RE: PETITION NO. 1323 – Windham Solar LLC petition for a declaratory ruling that no Certificate of Environmental Compatibility and Public Need is required for the proposed construction, maintenance and operation of three 2.0 Megawatt AC and two 1.0 Megawatt AC solar photovoltaic electric generating facilities on an approximate 43 acre parcel located at 134 Bilton Road, Somers, Connecticut.

**Petition No. 1323**  
**Interrogatories**  
**Set Two**  
**November 30, 2017**

SHEET: 3 of 14

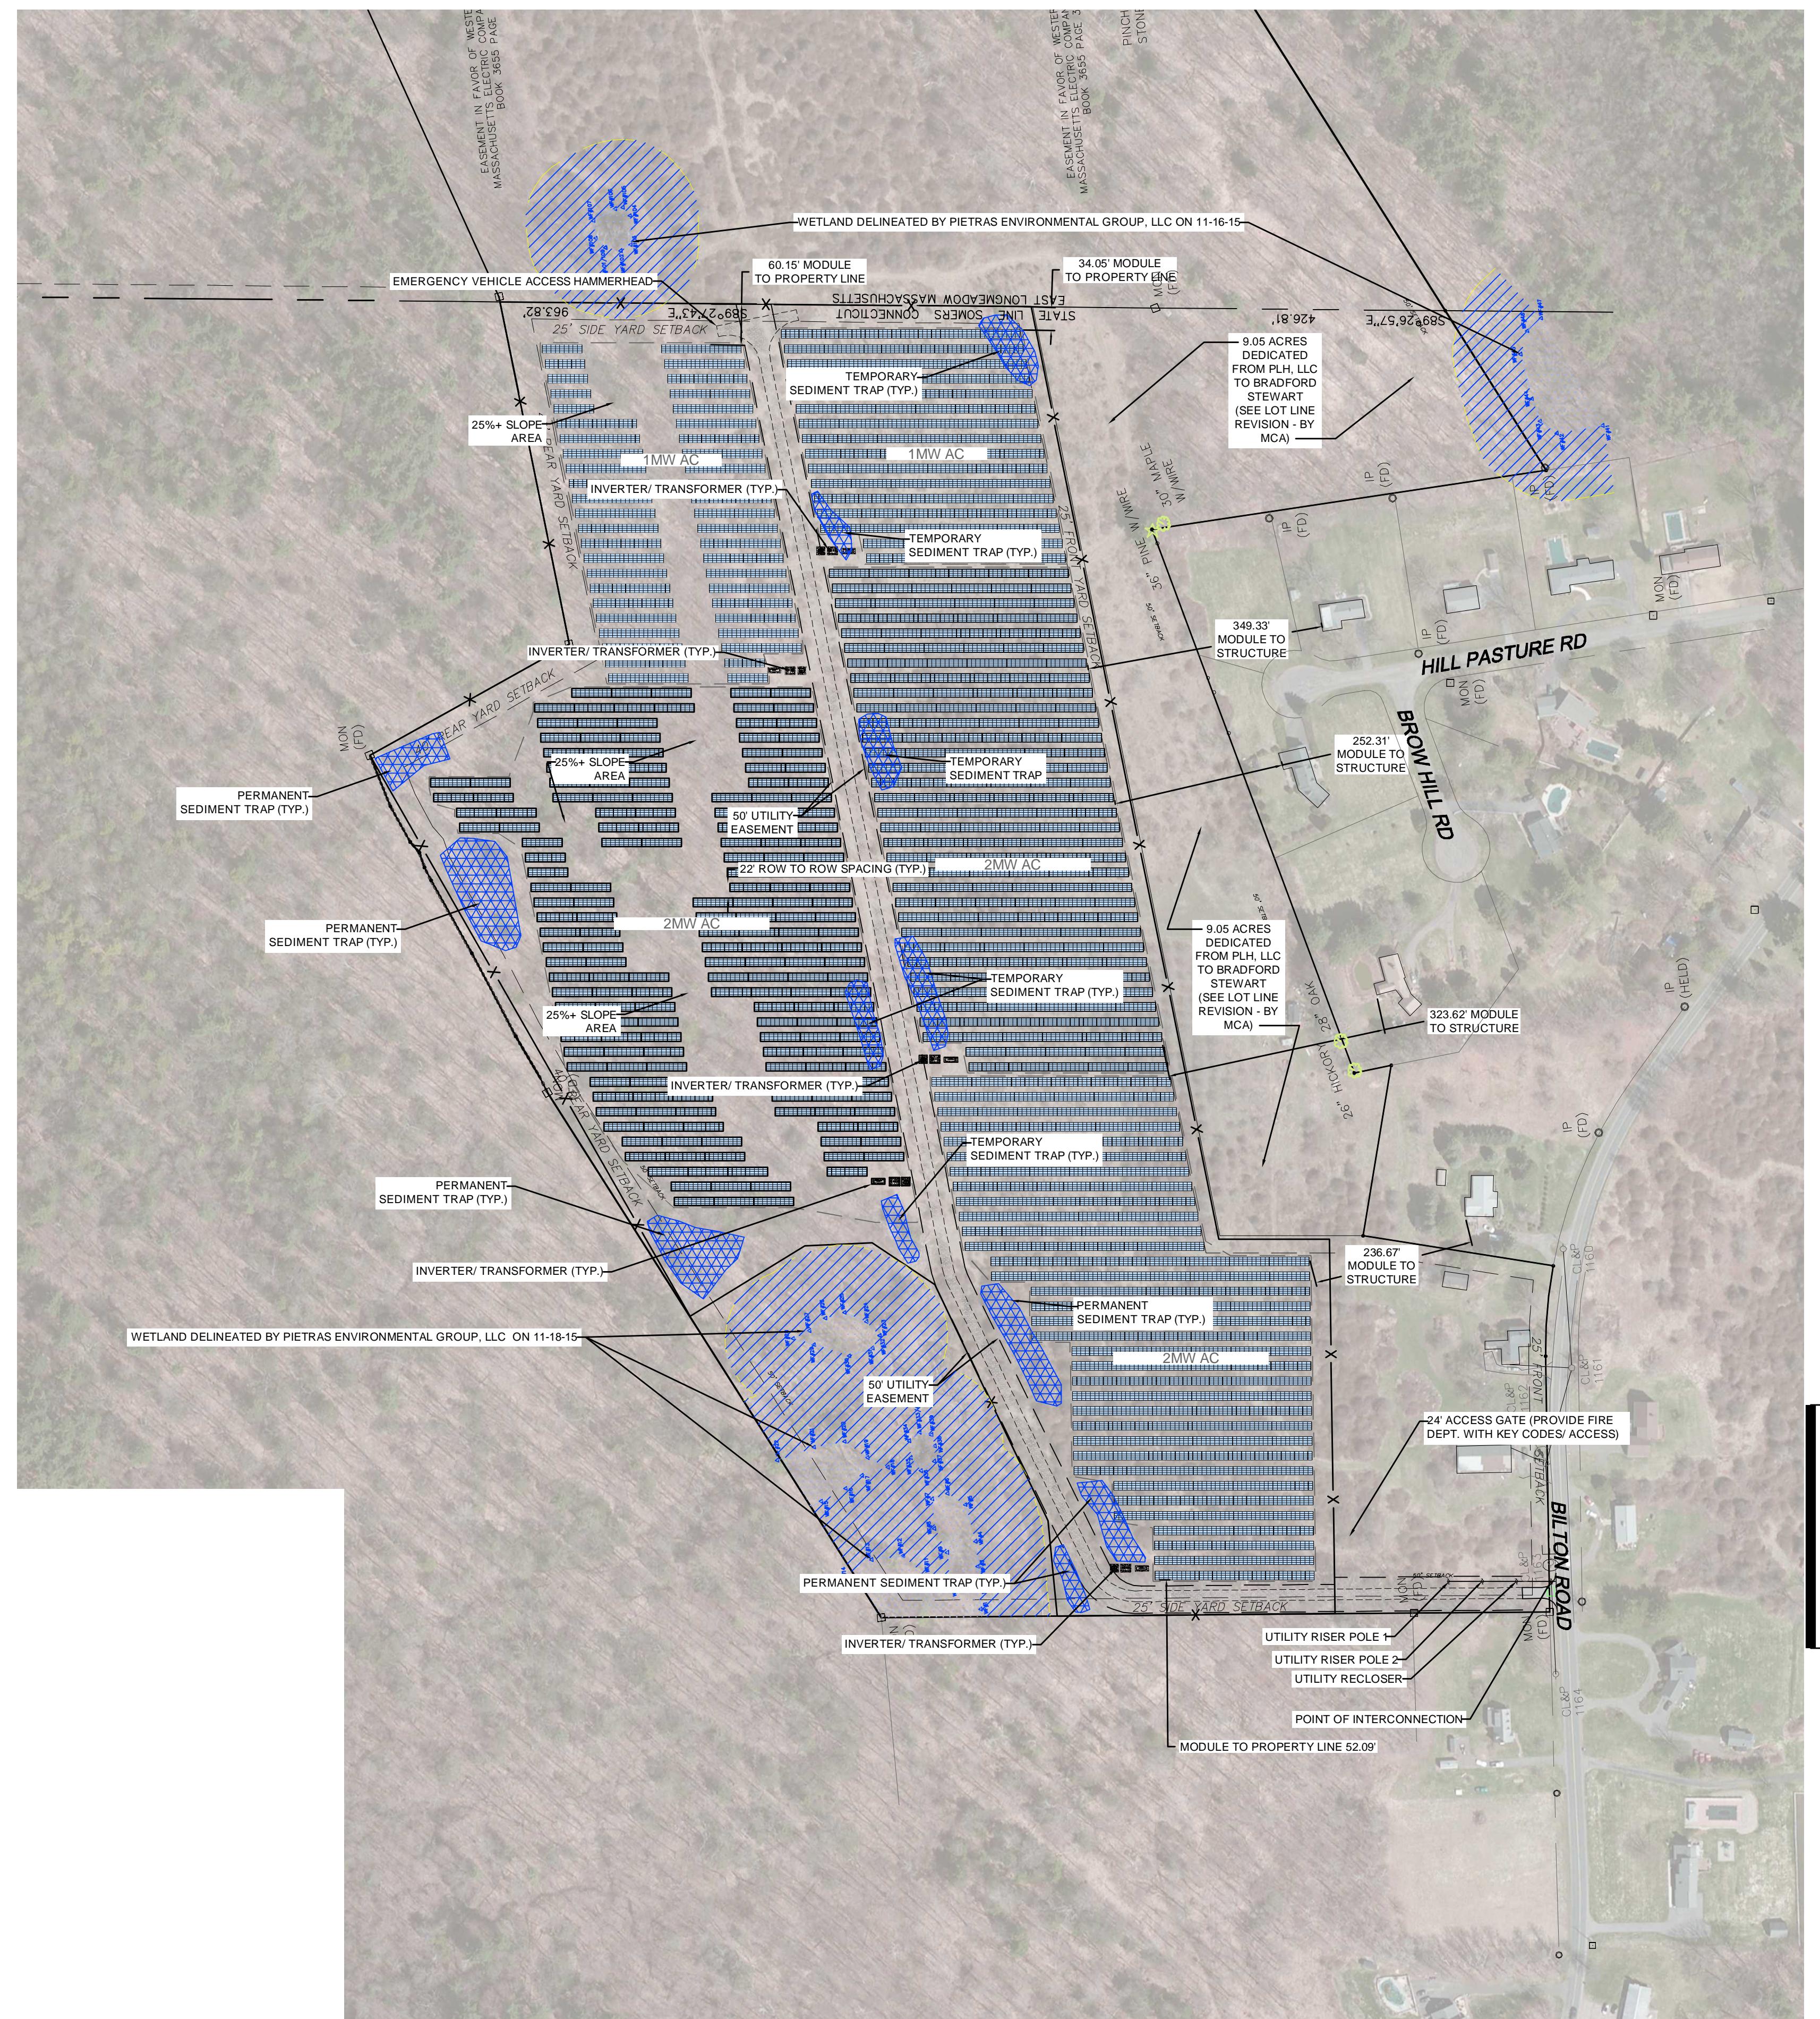
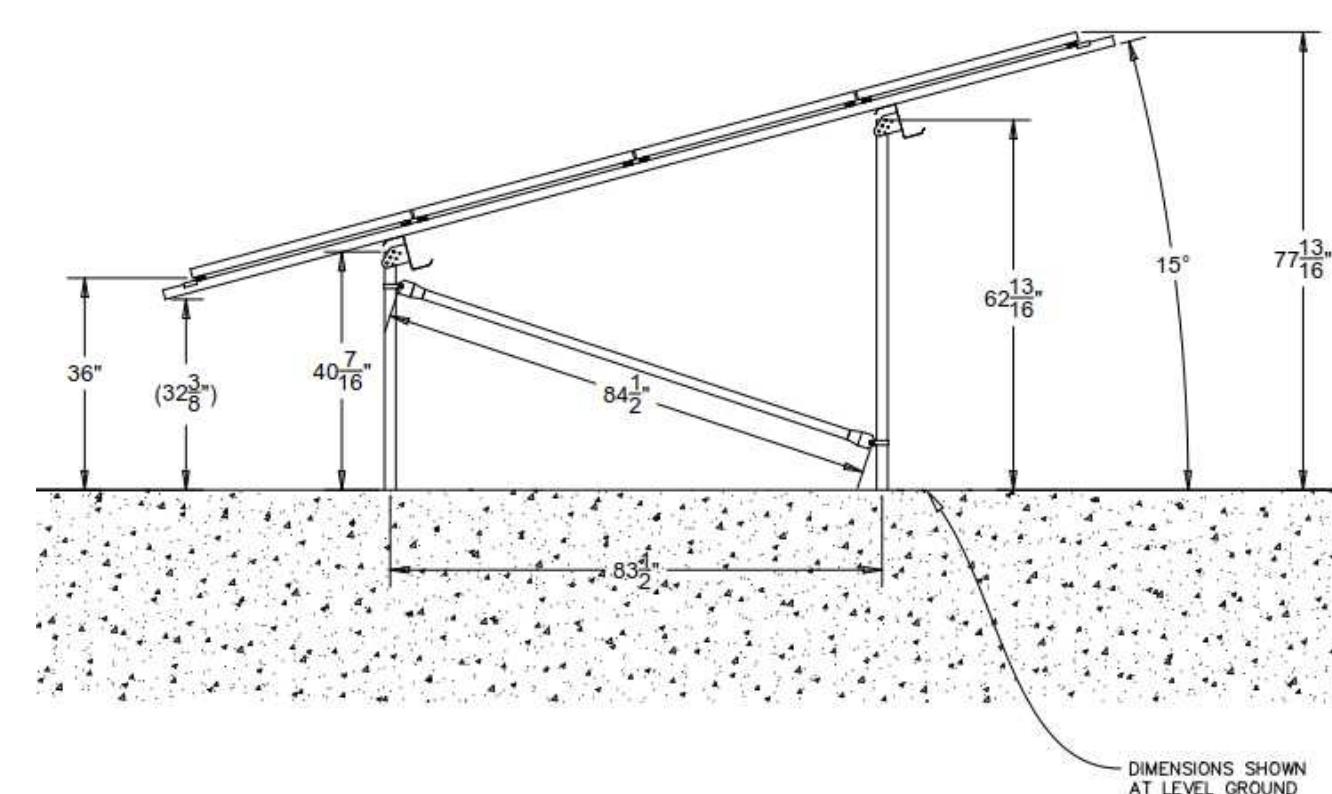
**CSC BS 1. Please provide Sheet 2 of 14 and Sheet 3 of 14 of Exhibit A to the petition.**

**CSC BS 20. On page 14 of the petition and Sheet 7 of 14 of Exhibit A, both reference a 50-foot wetland buffer. Sheets 3 and 4 of 14 of Exhibit A reference a 100-foot wetland buffer. Please clarify.**

Pages 2 and 3 of Exhibit A to the Petition is attached to this response as Exhibit A. Page 2 is the ALTA survey and Page 3 is the main site plan page. Page 3 was included in the electronic PDF submittal, but was omitted from the hard copy submission.

The wetland buffers shown in the plan set provided as Exhibit A to the Petition depict 100 foot buffers. None of the facilities are being proposed within 100 feet of a wetland.

# OVERALL SITE PLAN

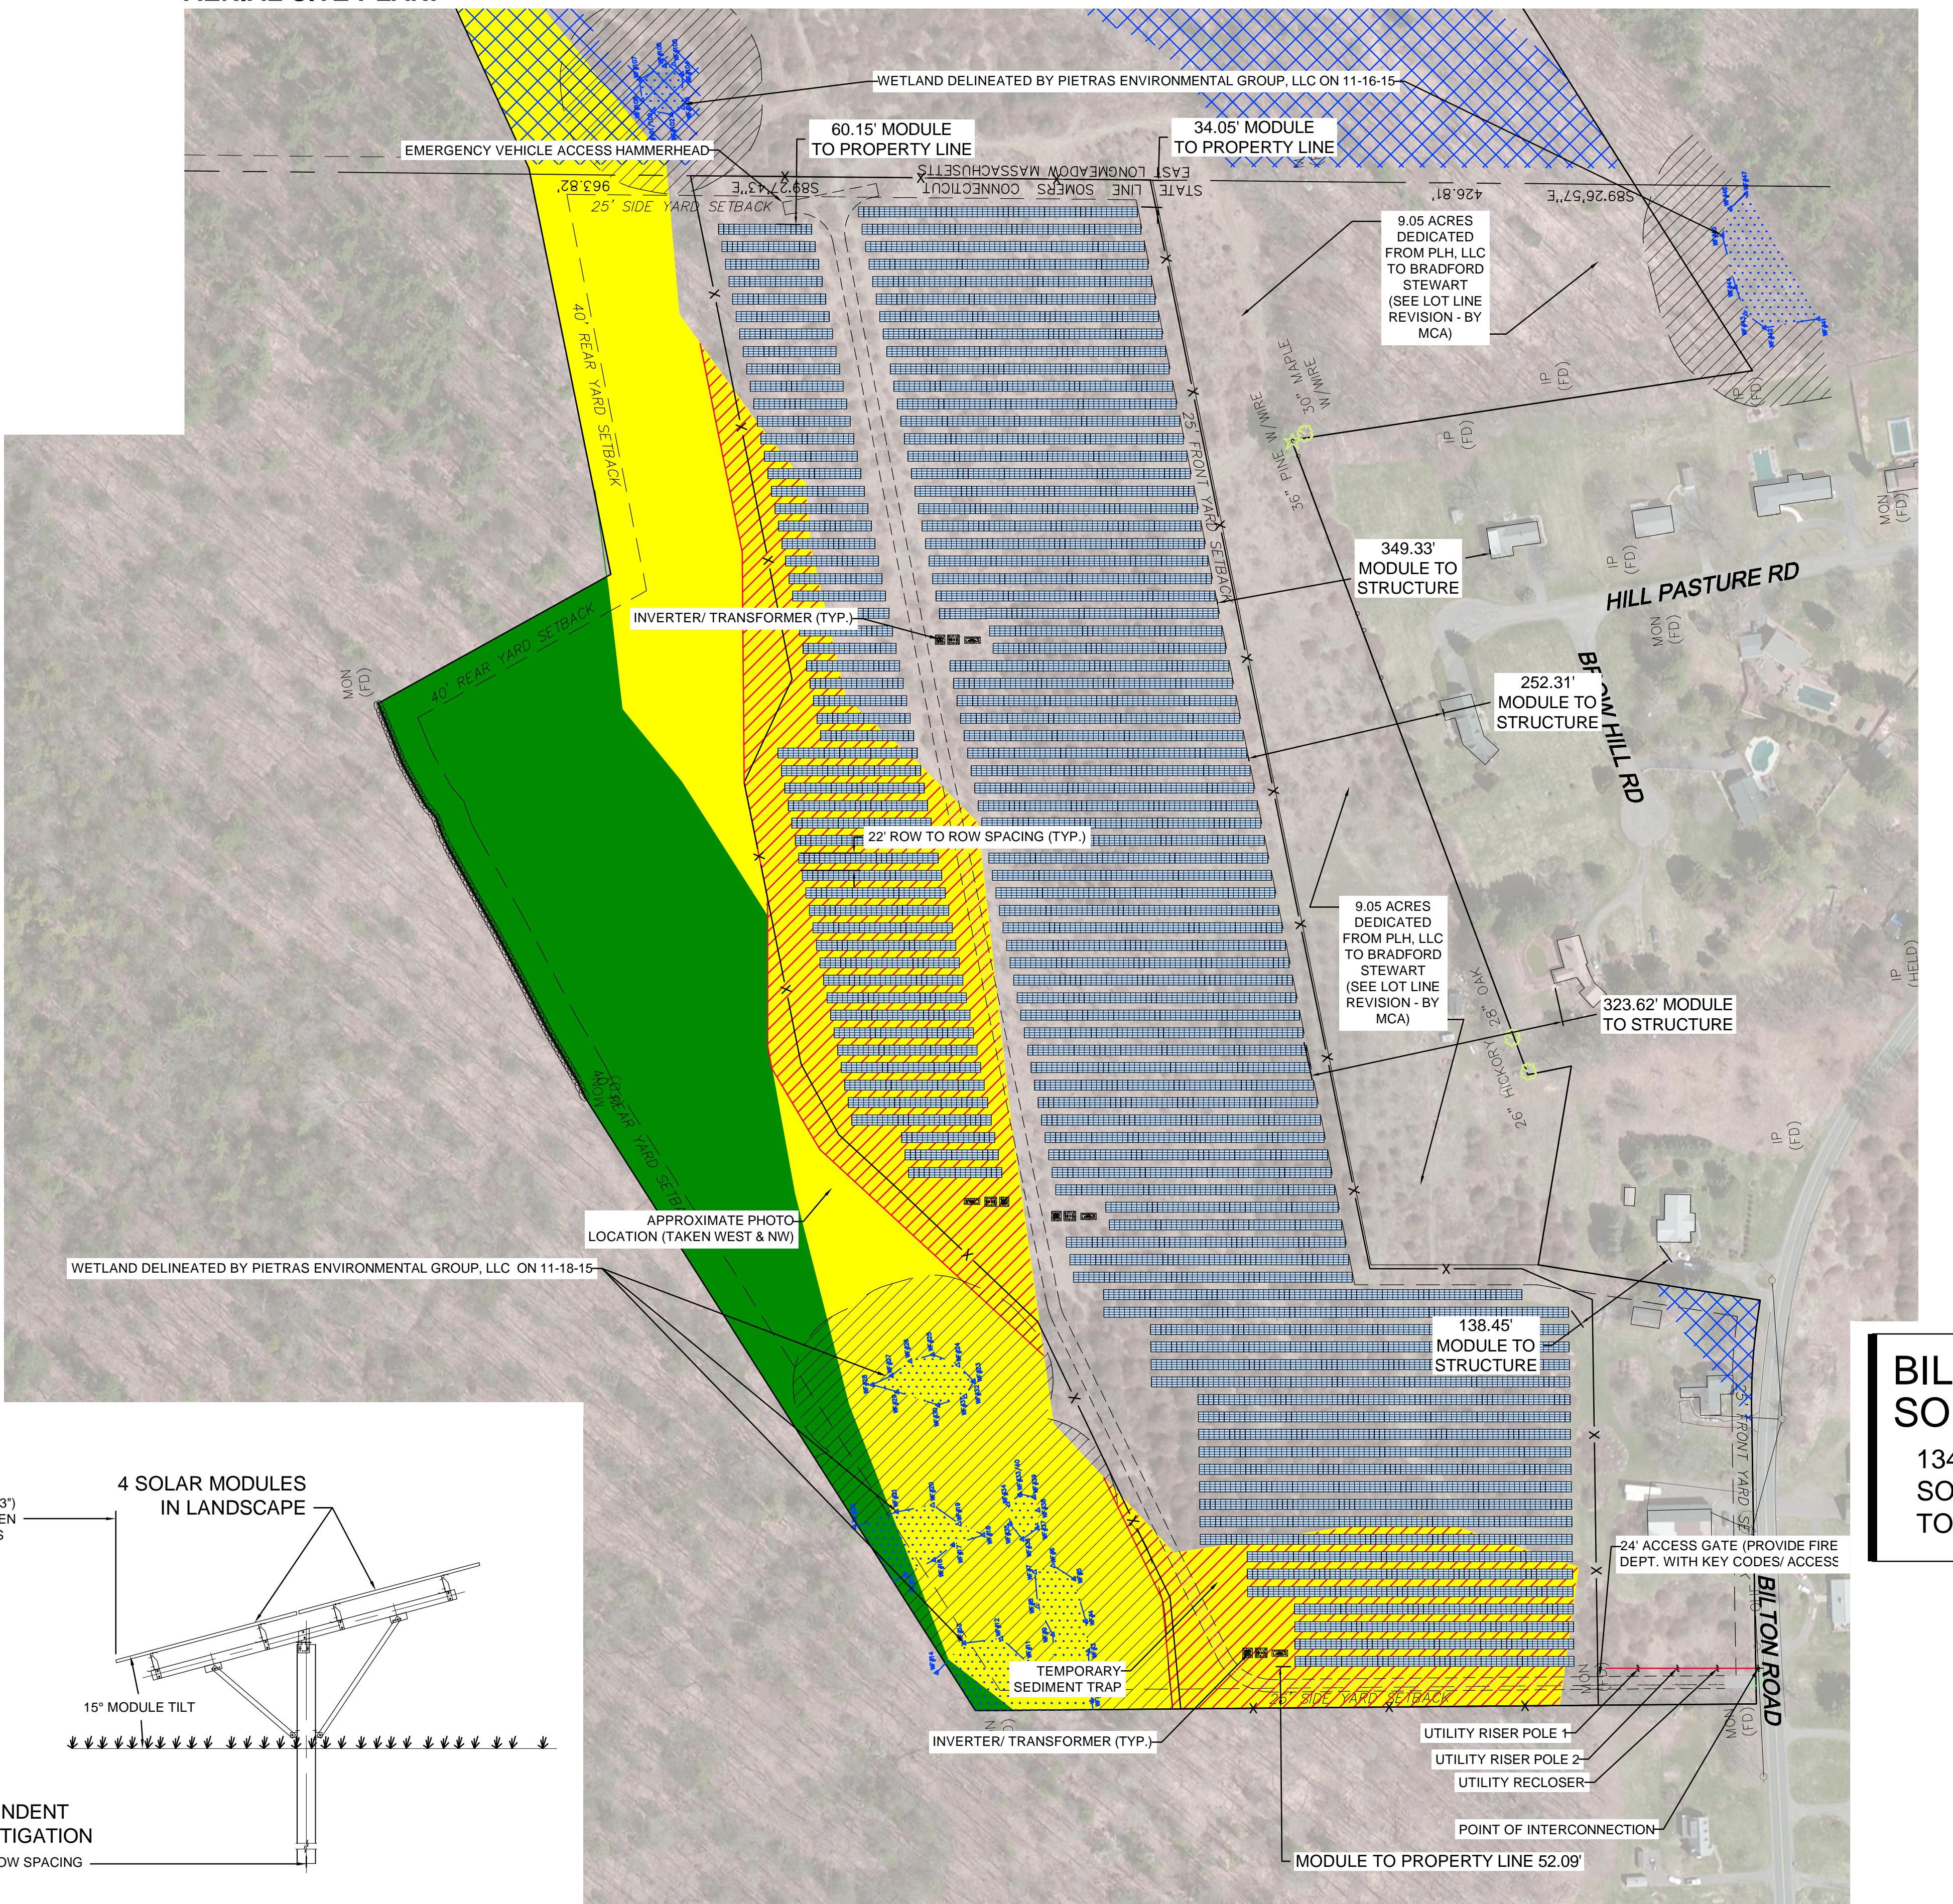
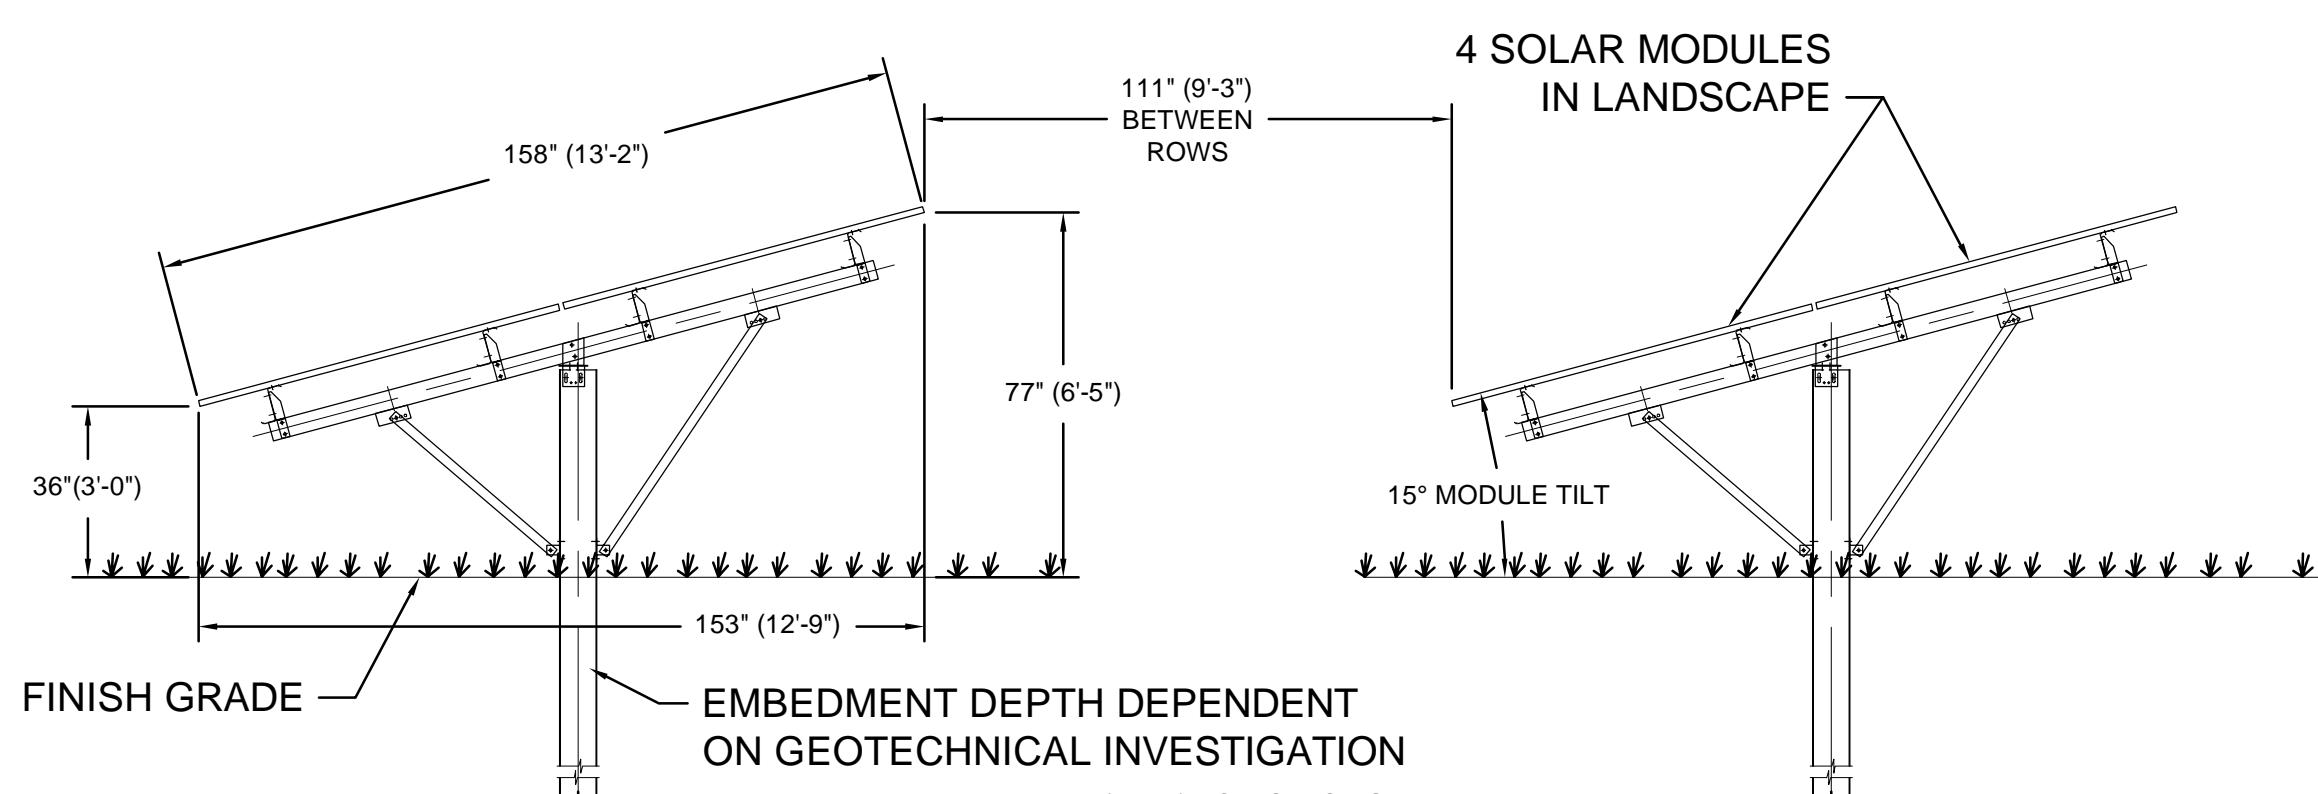
**CSC BS 7. Under Connecticut General Statutes §16-50k, “Core forest” is defined as unfragmented forest land that is 300 feet or greater from the boundary of forest land and non-forest land. Small core forests are core forest patches that are less than 250 acres. Medium core forests are core forest patches that are between 250 acres and 500 acres. Large core forests are core forest patches that are greater than 500 acres. Would the removal of the 15.5 acres of trees referenced on page 18 of the petition impact core forest? If so, what type of core forest – small, medium or large?**

**CSC BS 8. Could the site layout be reconfigured to reduce the number of panels or relocate the panels off the west slope of the central and northern section of the site? Would this reconfiguration reduce the 15.5 acres of tree removal?**

**CSC BS 9. If the reconfiguration in question no. 8 is feasible, please submit an alternative site layout depicting the reduction in the number of panels or relocation of the panels off the west slope of the central and northern section of the site and a narrative describing the reconfiguration.**

If the area were considered part of a core forest, then the answer would be yes. Under the original site plan submitted with the petition, the proposed project would impact approximately 5.1 acres (as measured by the limits of the fence-line) of the 6 acres of tree area that are located on the property. The aggregate tree area was measured to be approximately 106 acres in size, so if it has been designated as forestland then it would be a small core forest. Assuming the area has been designated as forestland, an overlay of what would be the core forest is shown on the site plan is included with this response as Exhibit B.

Yes. Petitioner has enclosed an alternate site plan, attached as Exhibit “B”, which removes the solar facilities entirely outside of the tree area. This would result in the removal of 0 acres of trees from what would be the core forest (assuming the land were considered part of a core forest) and 7.5 acres of trees in the edge area, which would not in any event be considered part of a core forest.

Please refer to the enclosed alternate site plan attached as Exhibit “B”.
